ATTN: Document Control Desk
U.S. Nuclear Regulatory Commission
Washington, DC 20555-001SUBJECT:
Perry Nuclear Power Plant
Docket No. 50-440, License No. NPF-58
Completion of Required Action by NRC Order EA-12-051, Reliable Spent Fuel Pool
Instrumentation (TAC No. MF0802)

NRC Requests for Information
Page 1 of 23

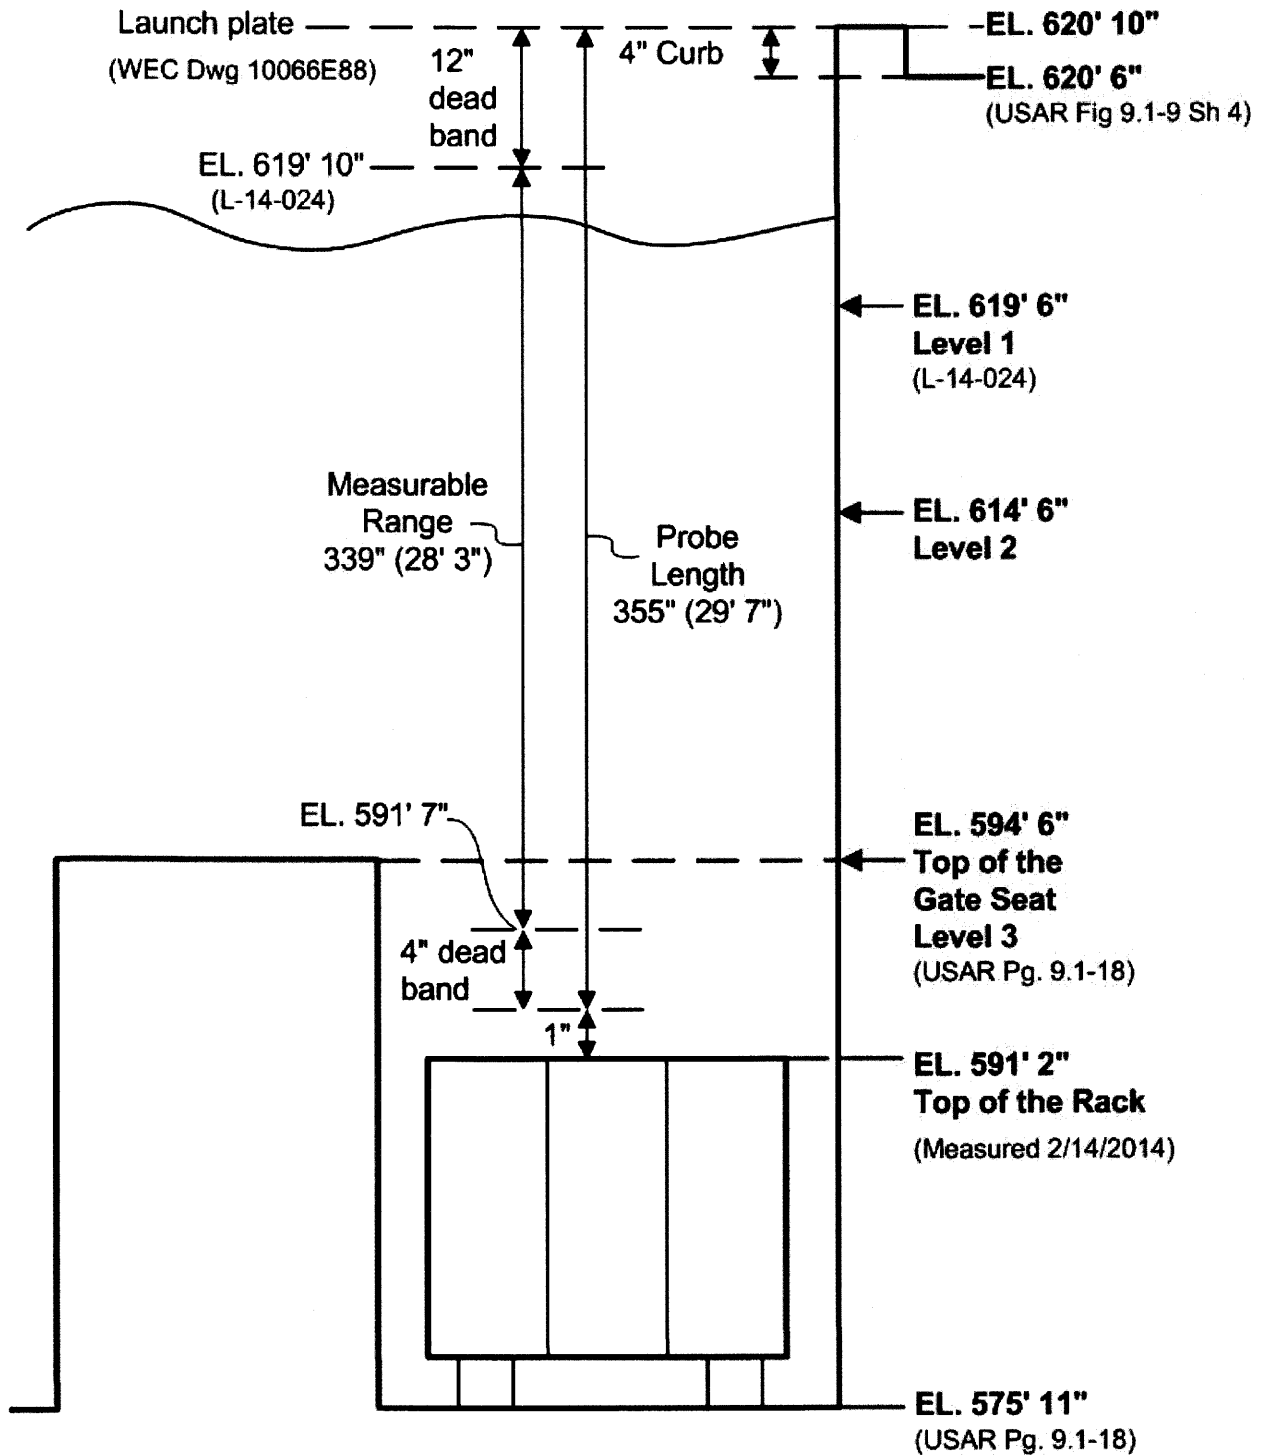
RAI-1:

Please provide a clearly labeled sketch depicting the elevation view of the proposed typical mounting arrangement for the portions of the instrument channel consisting of permanent measurement channel equipment (e.g., fixed level sensors and/or stilling wells, and mounting brackets). Indicate on this sketch the datum values representing Level 1, Level 2, and Level 3, as well as the top of the fuel racks. Indicate on this sketch the portion of the level sensor measurement range that is sensitive to measurement of the fuel pool level, with respect to the Level 1, Level 2, and Level 3, datum points.

By letter dated February 27, 2014, FENOC provided a sketch depicting the requested datum values. Subsequently, by FENOC letter dated August 28, 2014, Level 2 was changed. An updated sketch is provided below.
